Summit County Planning Commission (SCPC)
Thursday, October 30, 2025 - 3:00 p.m.
County of Summit, 470 Grant Street Building
470 Grant Street, 2nd Floor, Akron, Ohio
Meeting Agenda

1. **Heartridge Subdivision Phase 1 Replat - Replat– Sagamore Hills Township** - Located in Sagamore Hills Township along Hawthorne Drive. Applicant proposes to convert Block B (parcel number 4505603, 0.2662 Ac.) and Block C (parcel number 4505604, 0.3425 Ac.) of the Heartridge Subdivision Phase 1 into S/L 1-98 and S/L 1-99, respectively, with potential future development to occur on both lots.

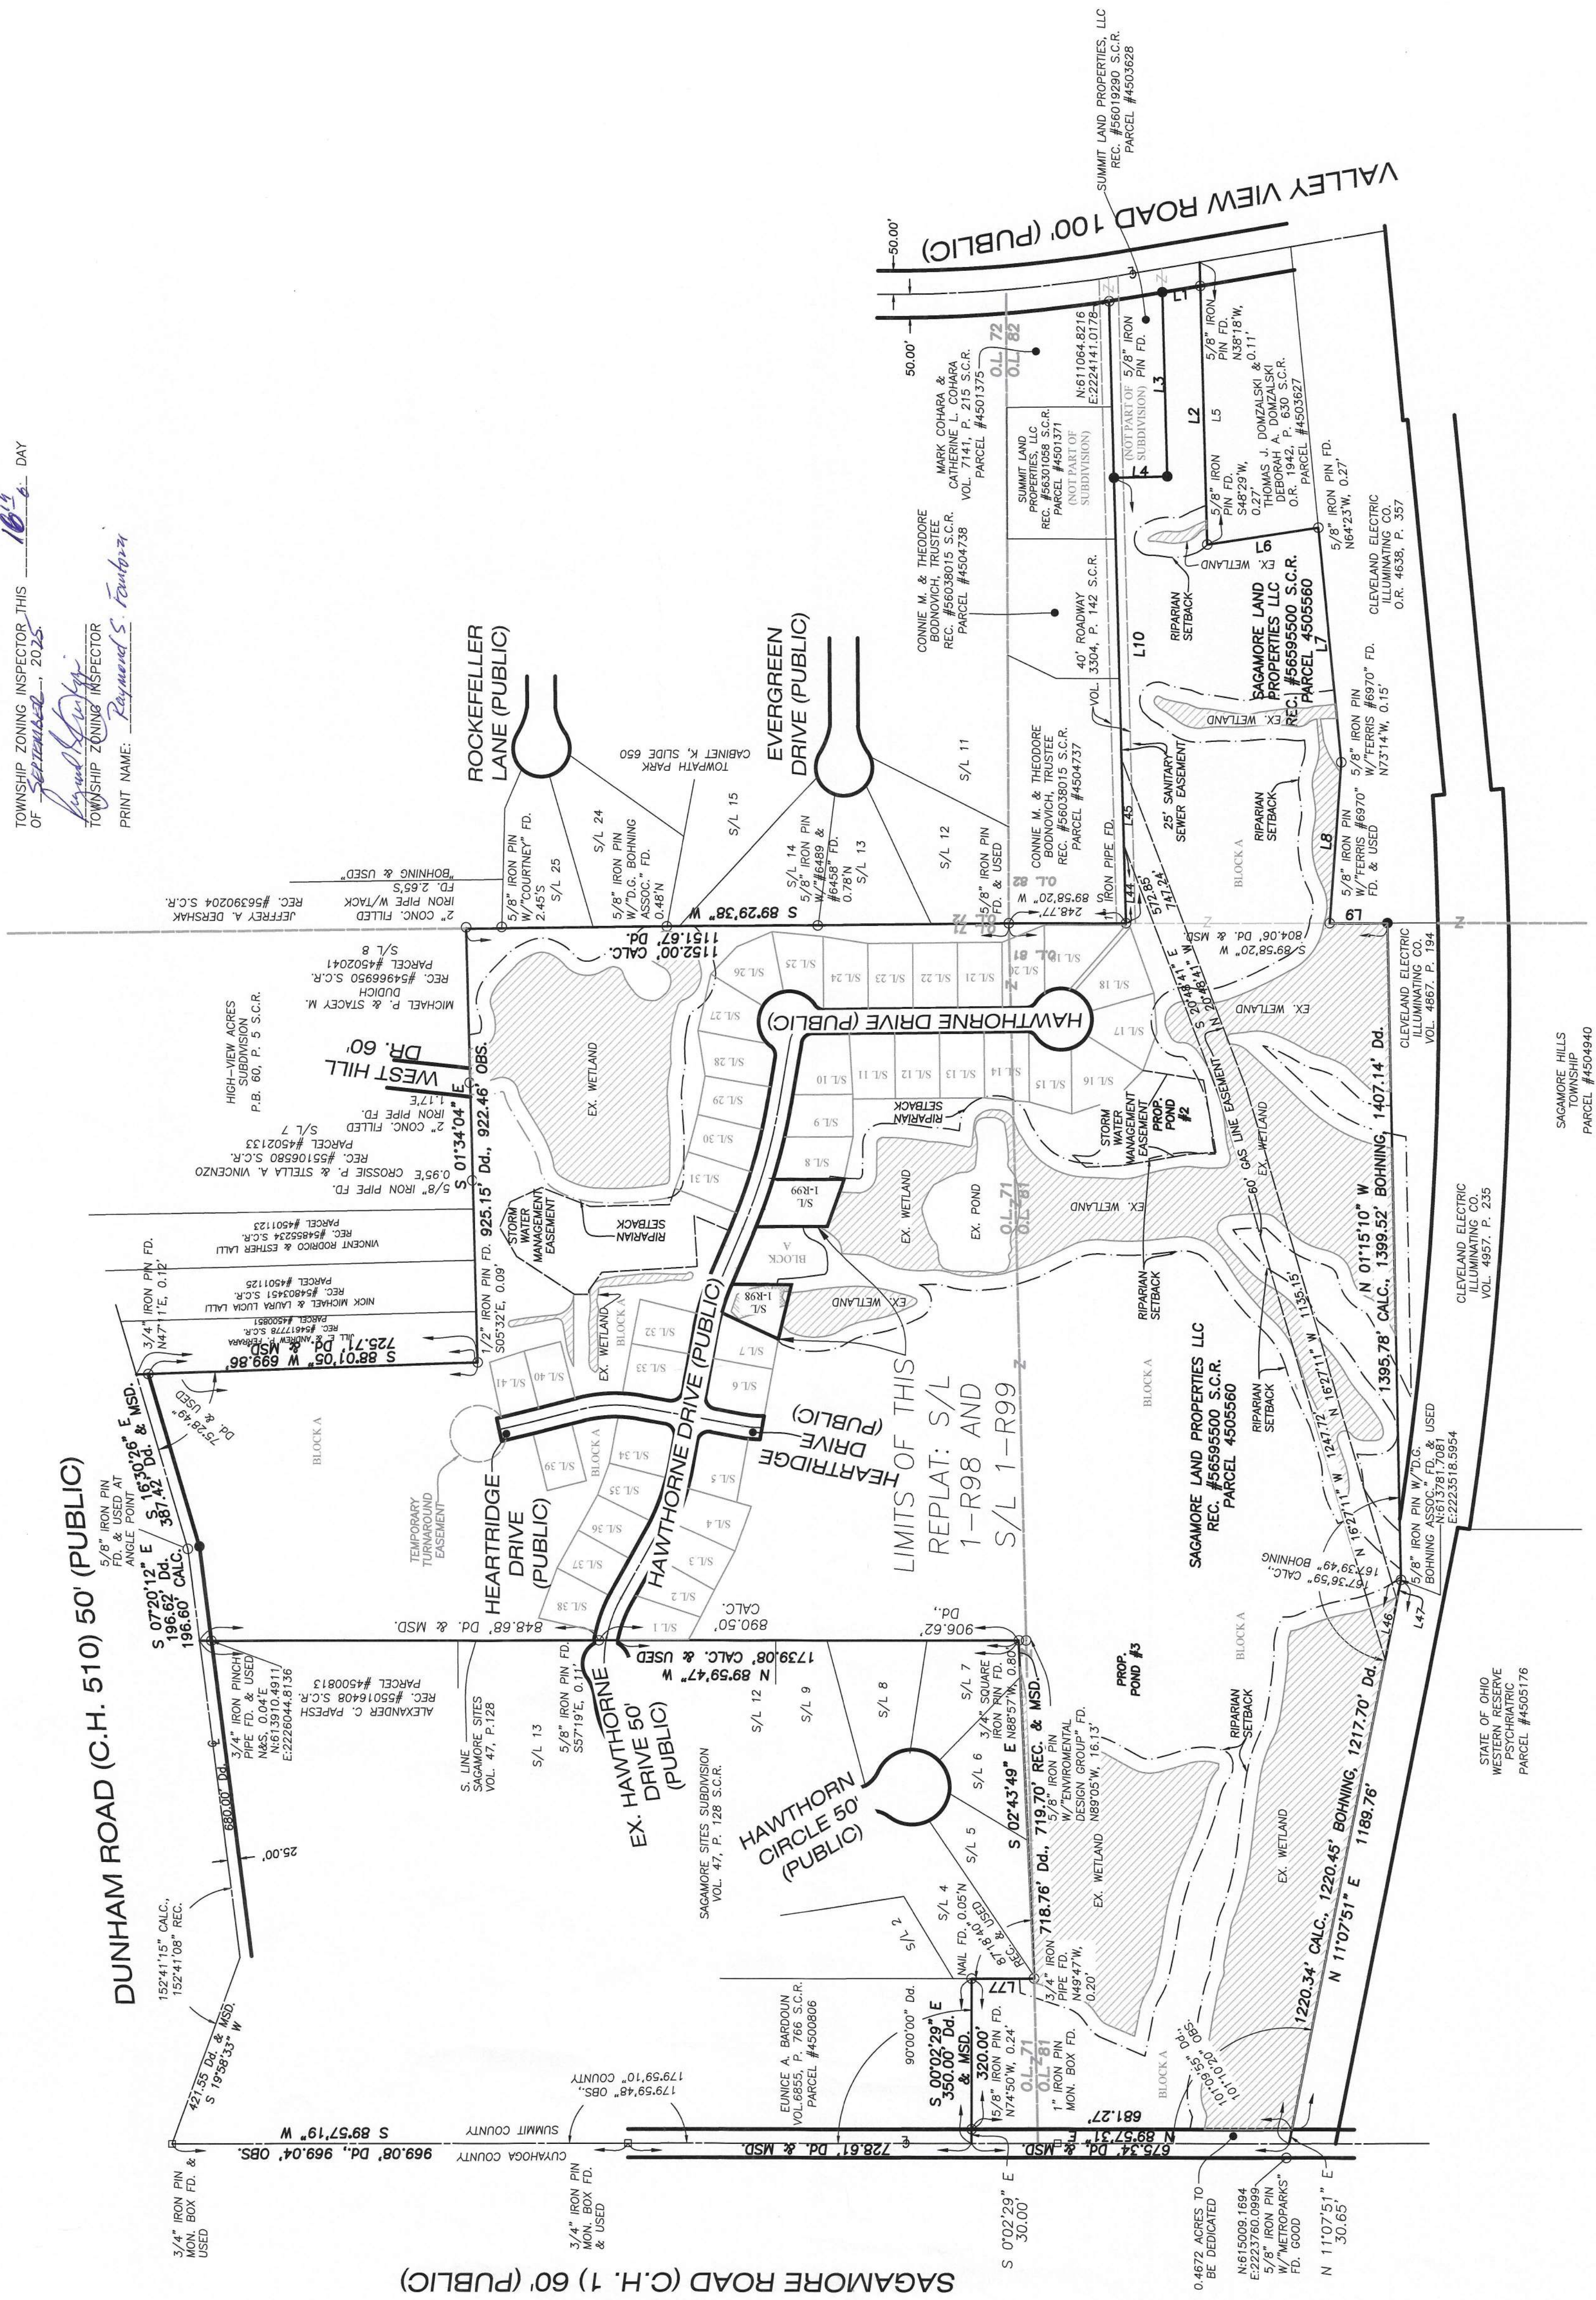
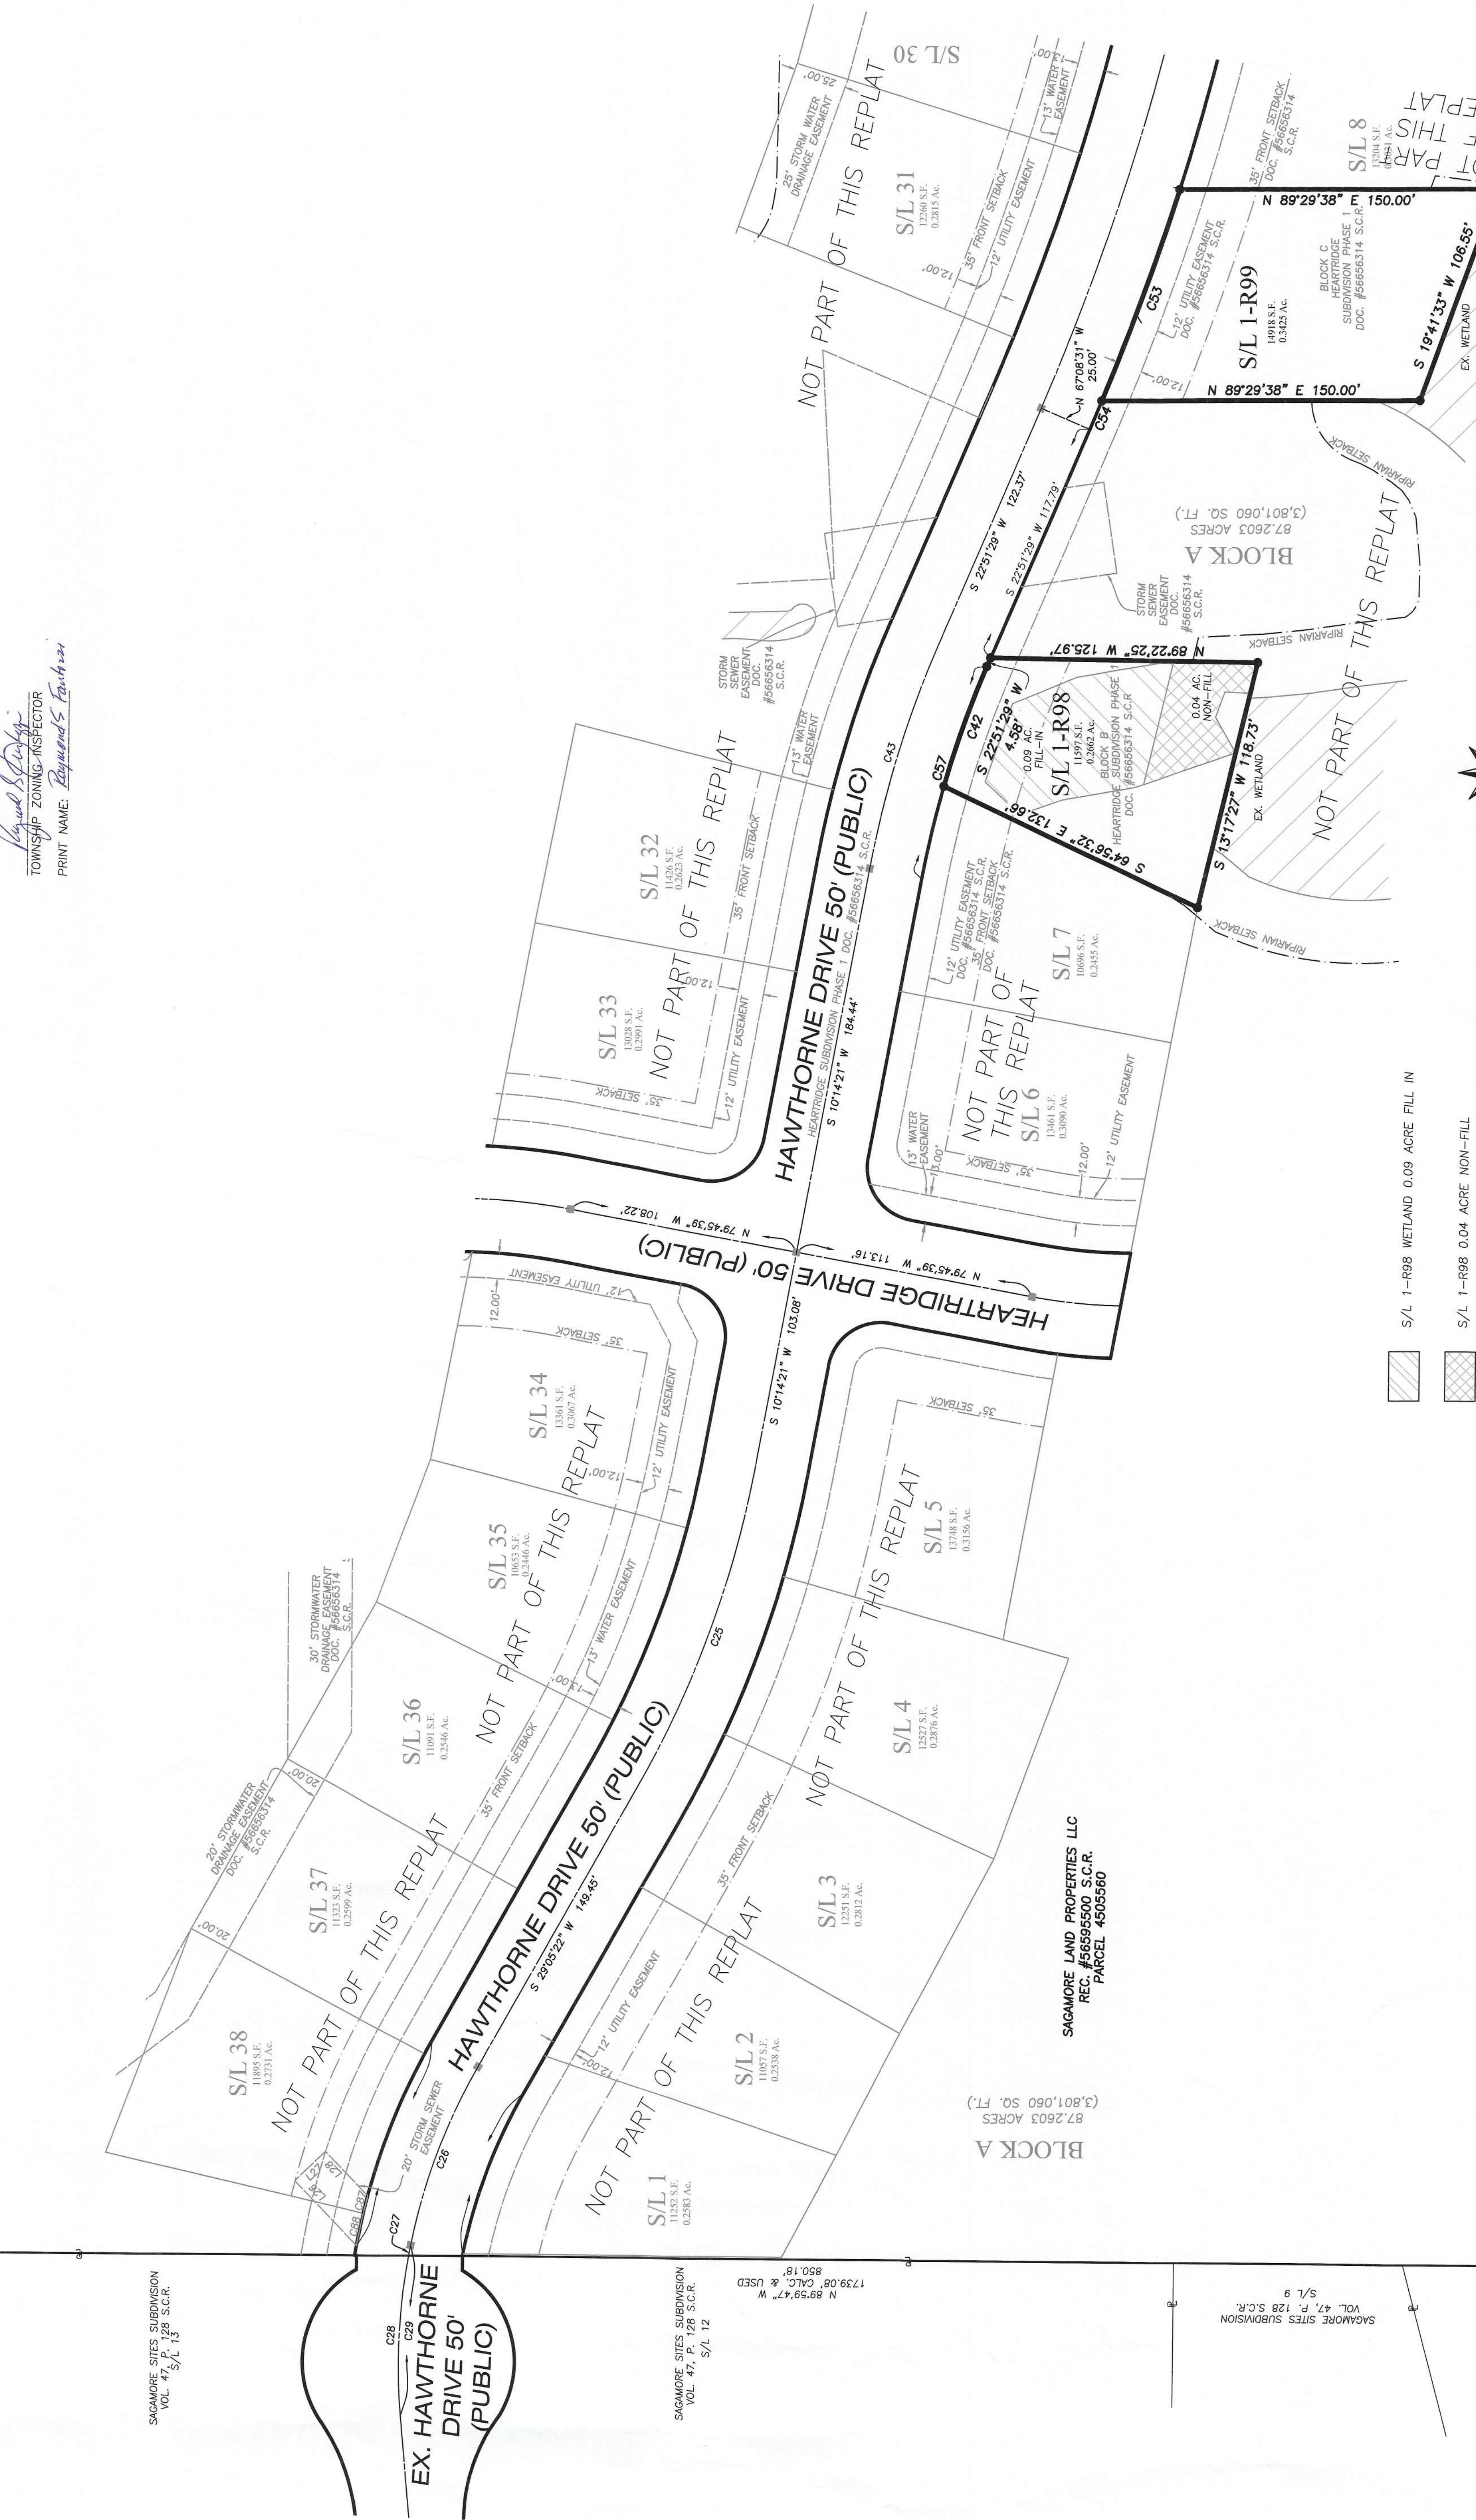
1. *The Sanitary Sewer Lateral locations will need to be defined on the Site Improvement Plans for Proposed Sublots 1-R98 and 1-R99...the Hawthorne Drive Pavement is not permitted to be disturbed to accommodate the Sanitary Sewer Laterals.*
2. *All outstanding Survey related comments have been adequately addressed.*

Staff Comments: After careful consideration of the evidence provided by the Summit County Engineer's Office, Summit Soil & Water Conservation District, Summit County Public Health and members of the general public, the SCPC Staff has determined that the applicant will need to delineate any riparian areas within the project area, and request a riparian variance from the Summit County Planning Commission before entertaining this replat proposal, unless the applicant can currently prove that no riparian areas exist within the project area.

Recommendation: It is Staff's recommendation that the SCPC **TABLE** this Replat until the applicant delineates any riparian areas within the project area, and request a riparian variance from the Summit County Planning Commission before entertaining this replat proposal, unless the applicant can currently prove that no riparian areas exist within the project area.

Photo taken by:
Peggy & Larry Spraggins
Feb 25, 2025 12:13 pm
Block B

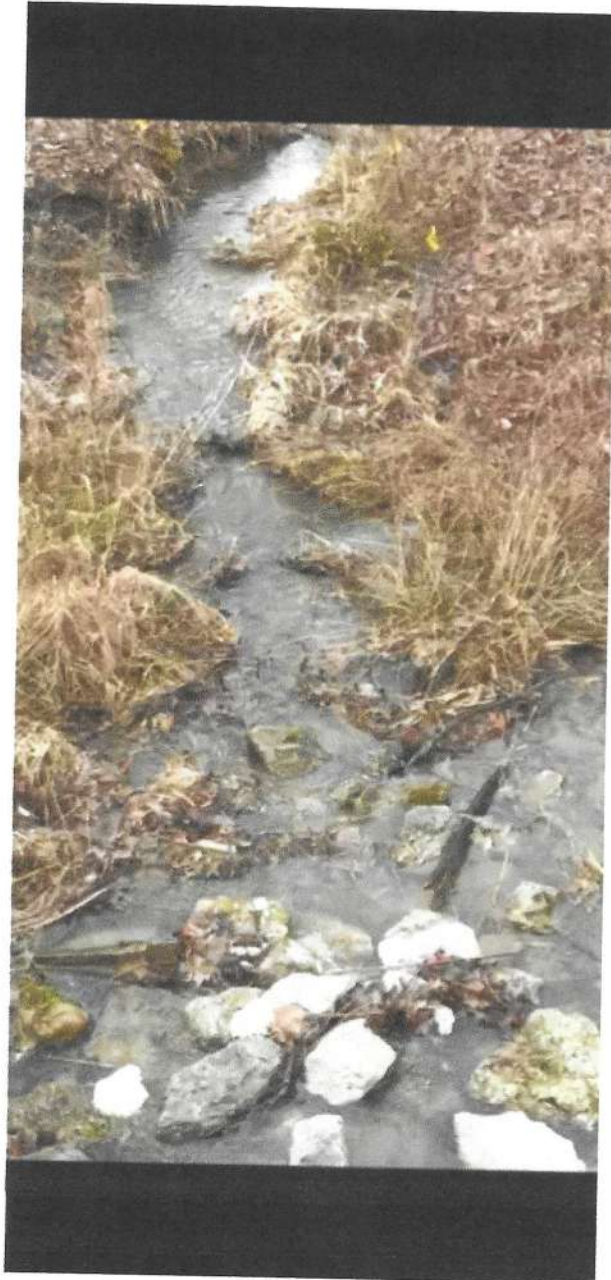
Based on the above facts, a reasonable person would be able to determine that Blocks B and C are still wetlands and to allow development on either parcel would be detrimental to the surroundings parcels and neighborhood in general. We therefore request that the Summit County Planning Commission deny the application for a replat of Heartridge Phase I.
